Title - Sujet COMPRESS. SYS FOR U66 AERODYN. LAB	
Solicitation No. - N° de l'invitation 31184-141845/B	Amendment No. - N° modif. 002
Client Reference No. - N° de référence du client 31184-141845	Date 2016-04-11
GETS Reference No. - N° de référence de SEAG PW-\$\$HP-912-70707	
File No. - N° de dossier hp912.31184-141845	CCC No./N° CCC - FMS No./N° VME
Solicitation Closes - L'invitation prend fin at - à 02:00 PM on - le 2016-04-26	
F.O.B. - F.A.B. Plant-Usine: <input type="checkbox"/> Destination: <input checked="" type="checkbox"/> Other-Autre: <input type="checkbox"/>	
Address Enquiries to: - Adresser toutes questions à: Pearson, Neil	Buyer Id - Id de l'acheteur hp912
Telephone No. - N° de téléphone (873) 469-3312 ()	FAX No. - N° de FAX (819) 953-2953
Destination - of Goods, Services, and Construction: Destination - des biens, services et construction:

This solicitation amendment 002 is raised to address bidders questions.

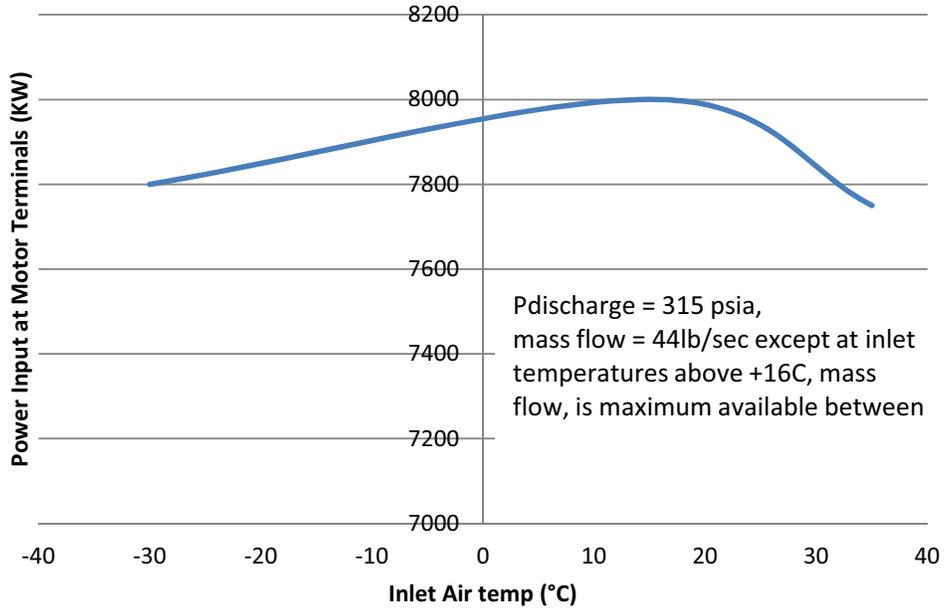
2. See Attached “Clarification Point for NRC Tri Sonic Phase reference”. We are proposing the Provision of key-phasor probe at bullgear instead of pinions for better speed resolution.

f. It can allow you to monitor more accurate dynamic analysis during the start-stop.

g. Start-stop of induction motor driven IG compressors do not typically allow pinion Bode diagrams anyway.

h. A single speed machines allow for easy ability to determine resonance and frequency for troubleshooting with existing radial vibration probes - vibration analysis tool (Adre system)

The provision requirements given in section 3.12.2.6 must be met. These requirements come from both PIP RESC001 and API672.
